February 10, 2010
U7-C-STP-NRC-100036

South Texas Project
Units 3 and 4
Docket Nos. 52-012 and 52-013
Response to Request for Additional Information

Attached are the responses to the NRC staff questions included in Request for Additional Information (RAI) letter numbers 299 and 302 related to Combined License Application (COLA) Part 2, Tier 2, Sections 3.7.1, 3.7.2 and 3.8.4.

Figure 03.07.01-20a

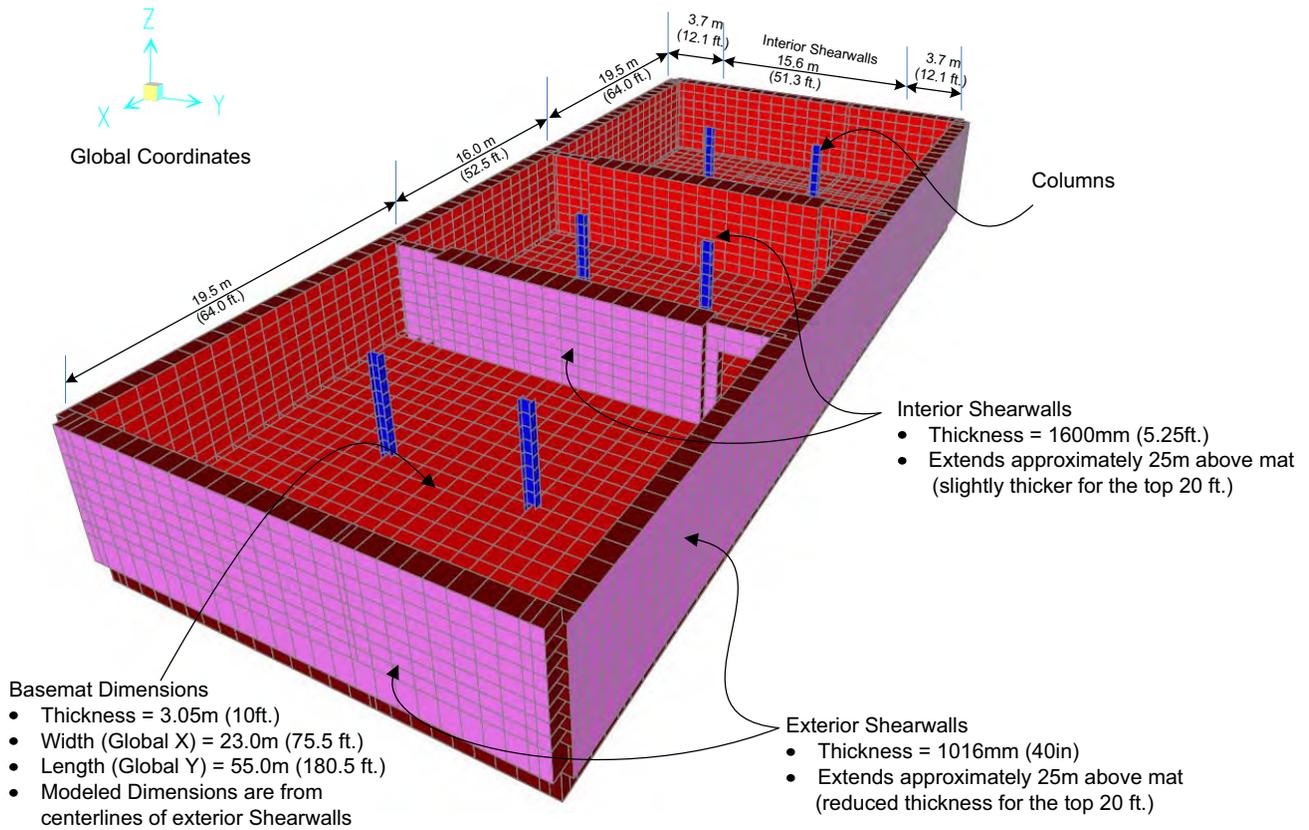
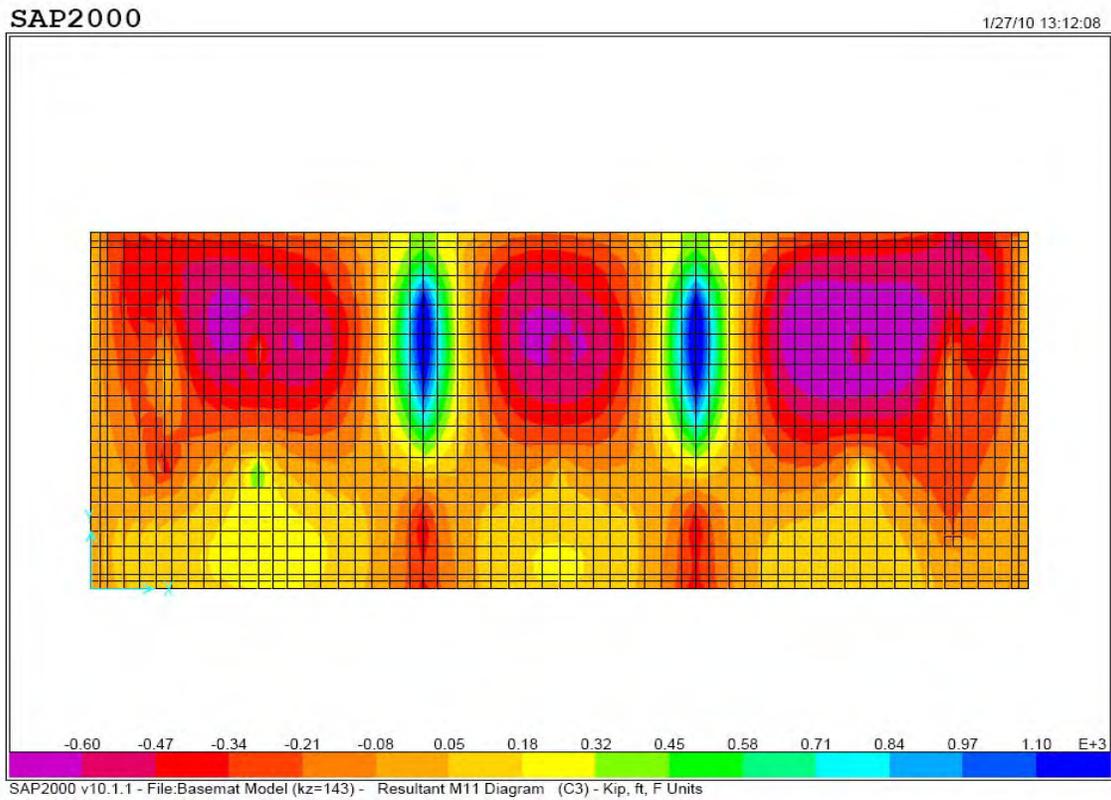
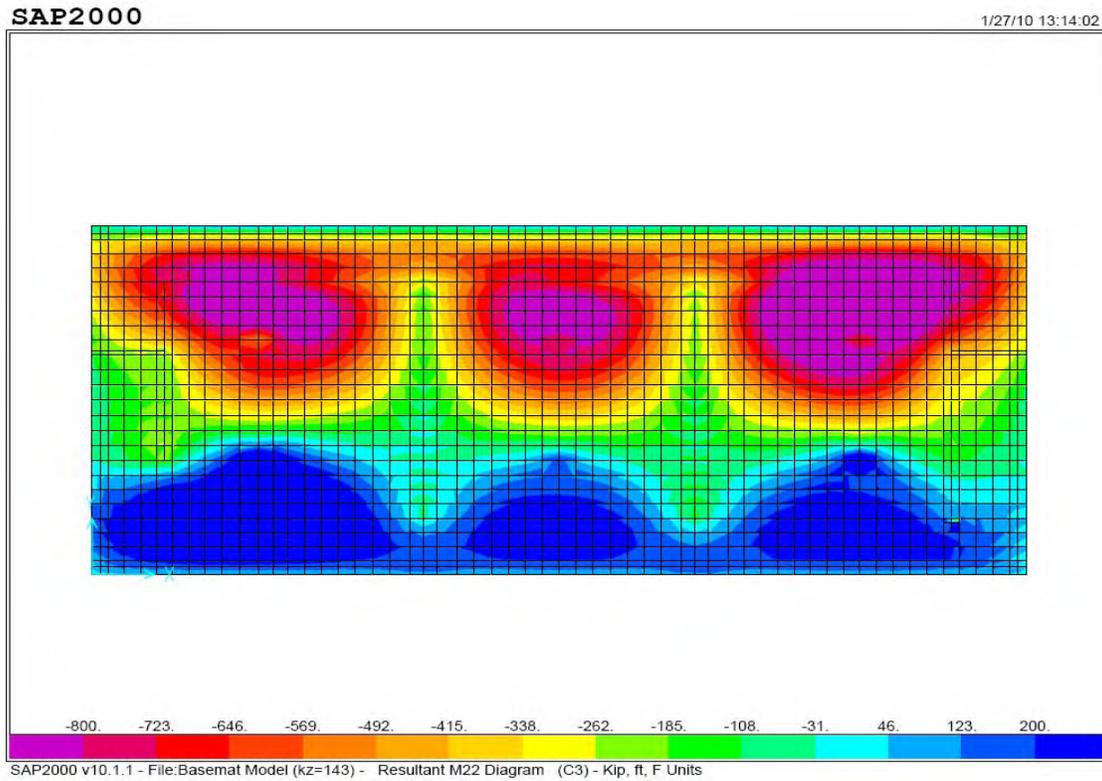
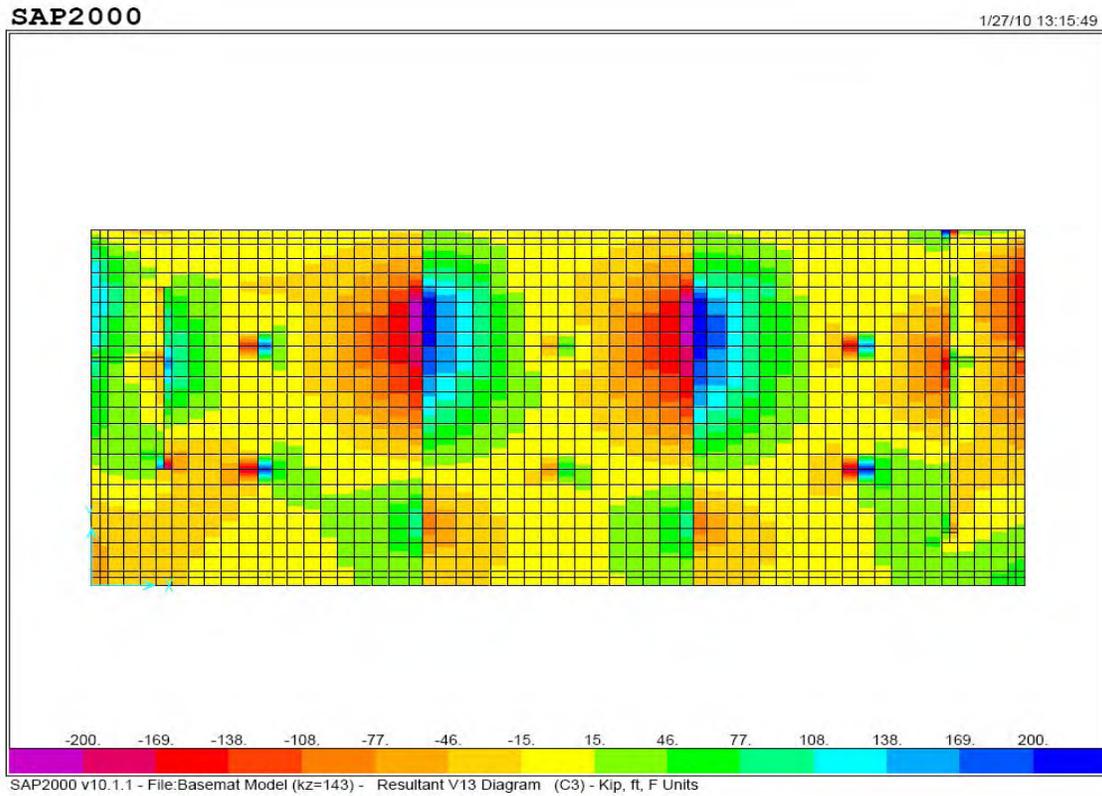
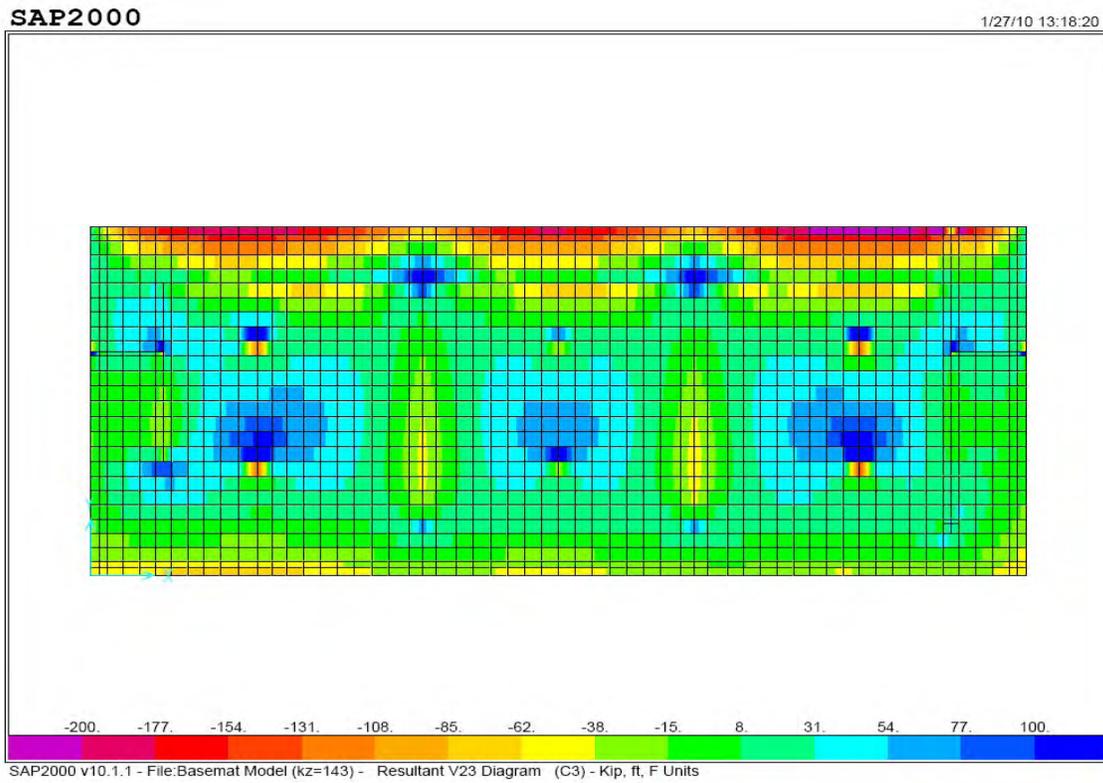
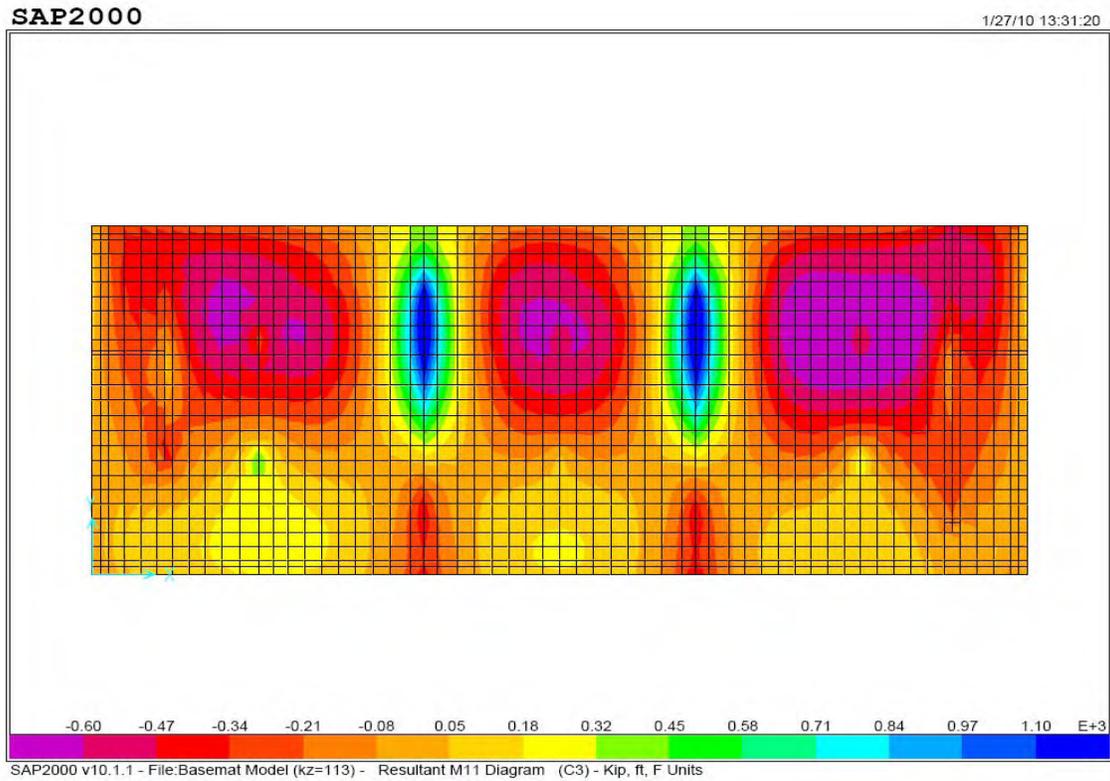
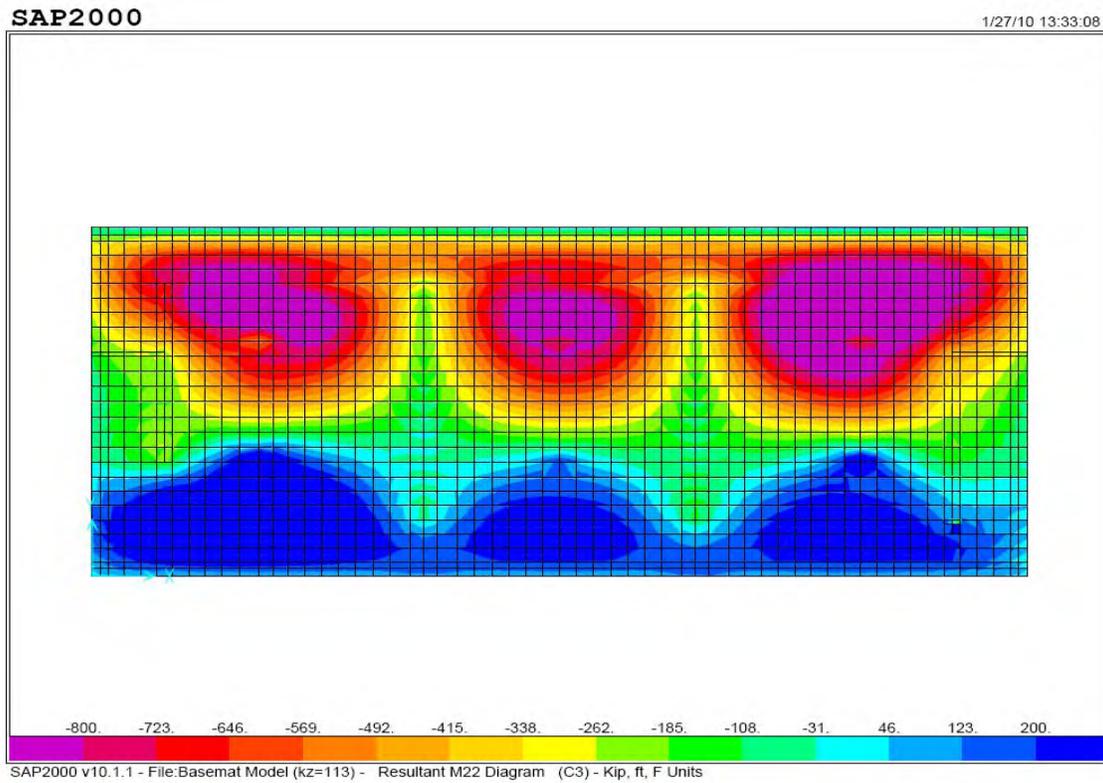
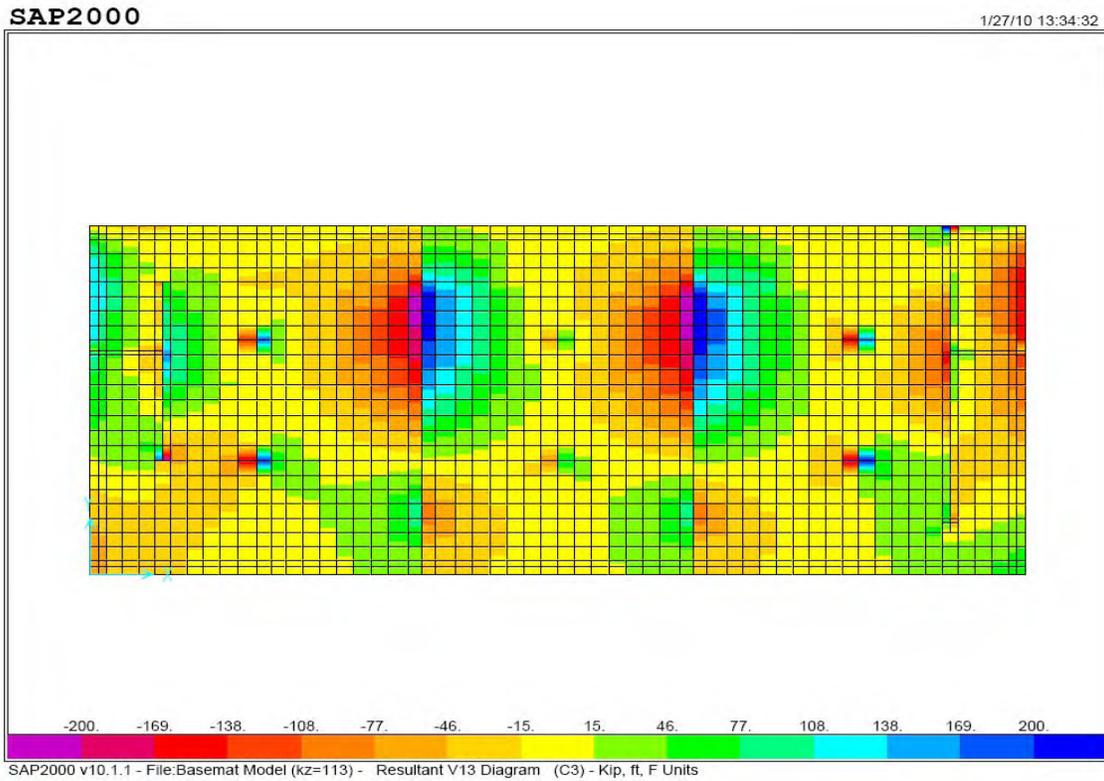
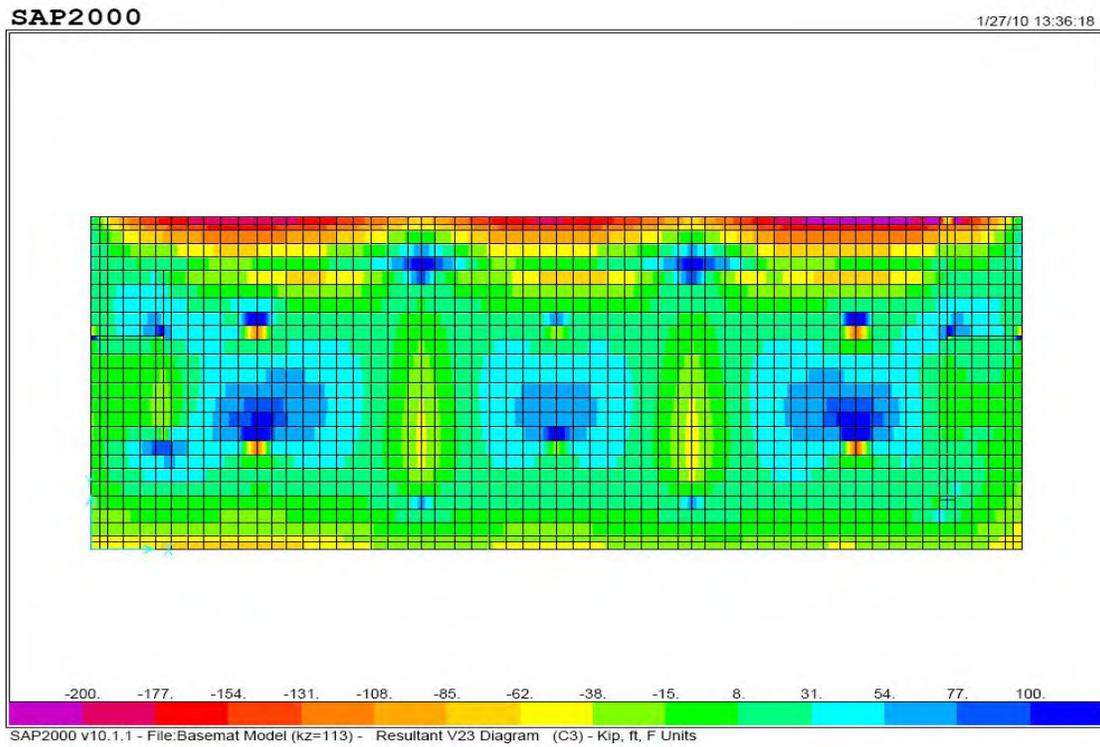
- (2) In the response to RAI 03.07.01-7, the applicant stated that "*The spring constant values are provided only for the Reactor Building in the DCD. Therefore, a comparison of the spring constant values is provided only for the Reactor Building.*" This justification for not evaluating the effect of site-specific shear wave velocity on the Control Building (CB) foundation design is not acceptable. The applicant is requested to further justify that the design of the CB foundation at the STP site would still be bounded by the standard plant CB design.

As noted in part (2a) of this response, the calculated STP site-specific soil spring constants for the upper range and best estimate cases are the same as, or higher than, the best estimate soil spring constants used for the standard design. Higher soil spring constants at the STP site will result in mat design forces smaller than those used for the ABWR CB design. The lower range site-specific soil spring constants are lower than the best estimate DCD spring constants. However, even with lower range site-specific spring constants, the ABWR CB mat design is adequate for the STP site for the following reasons:

- Considering the size and geometry of the CB, arrangement of the exterior and interior shear walls, thickness of the shear walls (39 inch exterior walls and 63 inch interior walls), and the mat thickness (i.e. 118 inches), the CB mat design is quite rigid and not so sensitive to spring constant values. This can be seen from the parametric study results presented in Figures 03.07.01-20a through 03.07.01-20i provided with this response.

Figure 03.07.01-20a shows the layout of the mat and the shear walls of a structure with very similar arrangement to that of the DCD CB. The model used for this parametric study is a three dimensional finite element model. This model was analyzed twice for the total dead load of the structure along with significant seismic moment about the X-axis (along East-West), once with DCD best estimate spring constants and the second time with lower bound site-specific spring constants. Figures 03-07-01-20b through 03-07-01-20e present contour plots of the resulting out-of-plane moments and shears when using DCD spring constants. Figures 03-07-01-20f through 03-07-01-20i present contour plots of the resulting out-of-plane moments and shears when using lower range site-specific spring constants. Comparison of the resulting out-of-plane moments and shears from these two cases show that there is no significant change in mat design forces.

Figure 03.07.01-13a

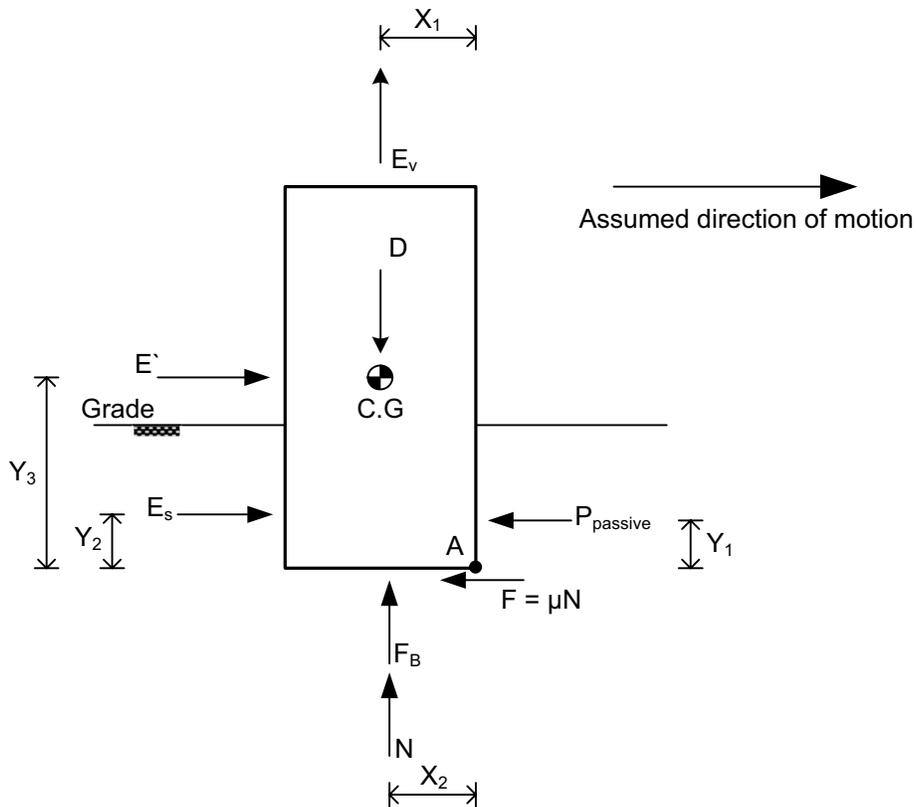
2. The response to item (c) of RAI 03.07.02-1 indicated that non-Category I structures with the potential to interact with Category I structures have not yet progressed to a point where sliding and overturning potential as a result of the SSE can be evaluated. However, as identified in SRP guidance 3.7.2I.8., the staff must review the applicant's seismic design of these non- Category I structures. As such, the applicant is requested to provide in the FSAR factors of safety against sliding and overturning including the basis of coefficient of friction used in the analysis during an SSE for Turbine Building, Radwaste Building, Service Building, Control Building Annex, and Plant Stack.

- Sliding and overturning evaluations are performed as shown in Figure 03.07.03-13a.
- Coefficient of friction for sliding evaluations for the four buildings shall be based on site-specific soil conditions.
- For simultaneous application of seismic forces in three directions the 100%, 40%, 40% combination rule as shown below will be used:

Figure 3H.6-40: SAP Finite Element Model for UHS and RSW Pump House Design

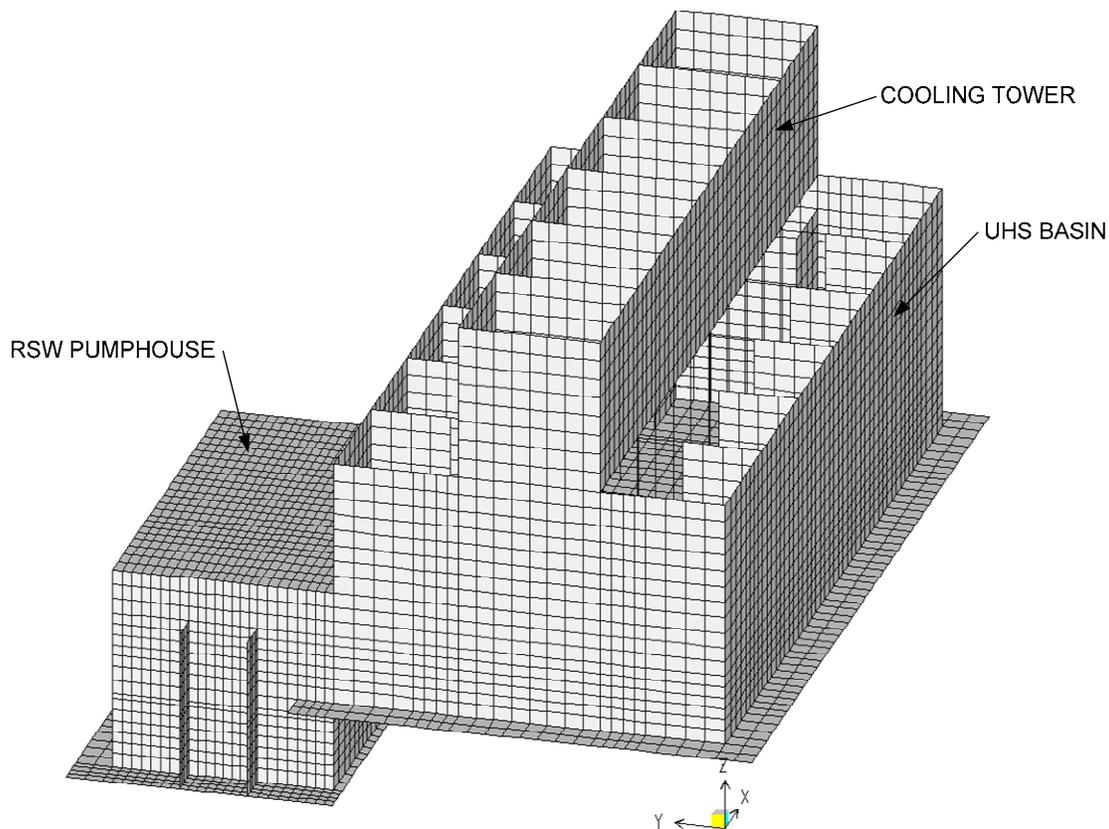
1. The finite element model referenced in Figure 3H.6-40 (this figure is not yet available in the response to RAI 03.07.01-13).
2. Method used to model the backfill material in the SSI analysis.
3. Method used to incorporate the ground water effects in the SSI analysis.
4. The analysis method used to obtain the seismic forces and moments for design evaluations.
5. The analysis method used to model concrete cracking.
6. The analysis method used to assess the effects of soil separation from the walls.

1. Figure 3H.6-40 was provided as part of the Supplement 1 response to RAI 03.07.01-13 (see letter U7-C-STP-NRC-090208 dated 11/19/2009) and for convenience is reproduced below. For additional information and figures for the Soil-Structure Interaction (SSI) analysis model of the Ultimate Heat Sink (UHS) and Reactor Service Water (RSW) Pump House, please see the response to RAI 03.07.02-16 submitted concurrently with this response.
